Fisheries and Oceans
Canada

August 11, 2010

Re: ExxonMobil Canada Properties – Hebron Project Draft Comprehensive Study Report

Thank you for the opportunity to review the Hebron Project Draft CSR.

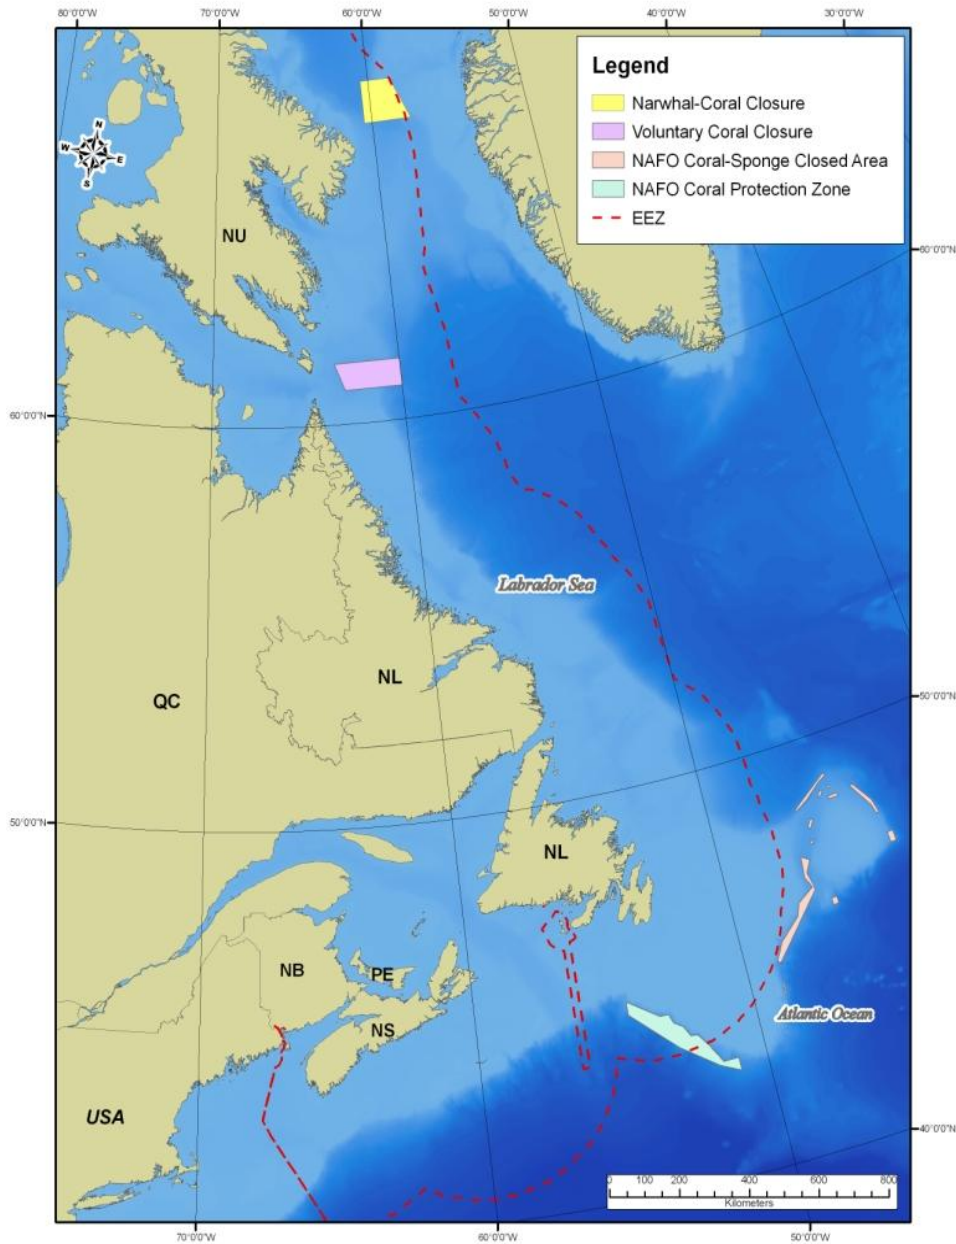
Figure 12-2 shows "Sponge/Coral Area" but does not note if this is an area where they are found, if these are VMEs (that is what is suggested in paragraph 3 on page 12-1 but not made clear), or closed areas. A map of NAFO Coral and Sponge closed areas and the NAFO Coral Protection zone exists. This data could be used to update table 12-2. This may be less ambiguous than using "sponge/coral area". See attached map.

Also the green area, southwest of the Flemish Cap, is the Beothuk Knoll as indicated by the map's legend. However, the Orphan Knoll also appears as a green area north of the Flemish Cap, but is not included within the map's legend.
